# Access Compliance Report

## Public Rights-of-Way

Intersection ID: 16513	Main Street: BILTMORE_DR	Cross Street: COLVILLE_RD	Location: NW
ADA ID: 8572489F2500	Ramp Type: Perp	Initial Pass/Fail: Fail	Overall Compliance: No
Codes/Mitigation Info/Possible Solution		Field Measurements/Component Compliance	
Severity Score: 12.5

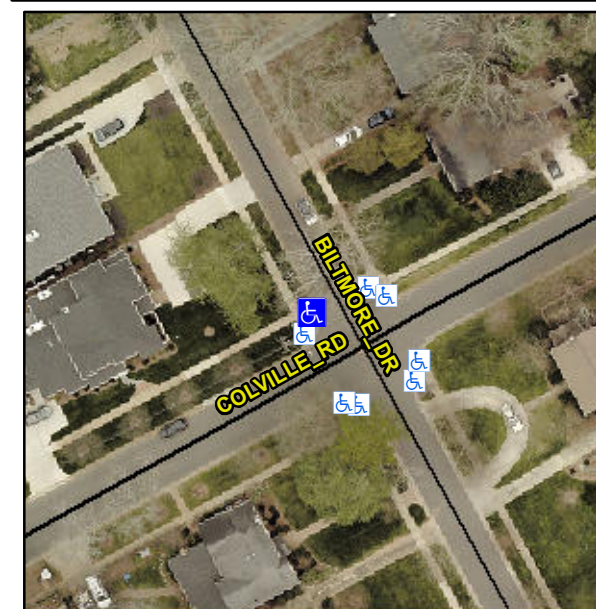
Compliance	Description	Data	Compliance	Description	Data
N/A	Ramp Length (in)	77.0	No	Ramp Slope (%)	9.1
Yes	Ramp Width (in)	48.0	Yes	Ramp XSlope (%)	1.6
N/A	Flare Type LT	N/A	N/A	Flare Type RT	N/A
N/A	Flare Slope LT (%)	N/A	N/A	Flare Slope RT (%)	N/A
N/A	Flare Traversable LT?	N/A	N/A	Flare Traversable RT?	N/A
N/A	Landing Length (in)	N/A	N/A	DWS Provided?	N/A
N/A	Landing Width (in)	N/A	N/A	DWS Contrast?	N/A
N/A	Landing Slope (%)	N/A	N/A	DWS Length (in)	N/A
N/A	Landing X Slope (%)	N/A	N/A	DWS Full Width?	N/A
N/A	Landing Curb? (Y/N)	N/A	N/A	DWS Offset (in)	N/A
N/A	Shared Landing?	N/A			
N/A	Gutter Ponding?	N/A	N/A	Gutter Slope (%)	N/A
N/A	Gutter Lip Ht (in)	N/A	N/A	Gutter X Slope (%)	N/A
N/A	Painted X Walk1?	No	N/A	Painted X Walk2?	N/A
	X Walk 1 Direction	To NE		X Walk 2 Direction	N/A
N/A	X Walk 1 Width (in)	N/A	N/A	X Walk 2 Width (in)	N/A
	X Walk 1 Slope (%)	3.0		X Walk 2 Slope (%)	N/A
	X Walk 1 X Slope (%)	0.4		X Walk 2 X Slope (%)	N/A

**Remove & Replace Entire Ramp.**

**R304.2.2**
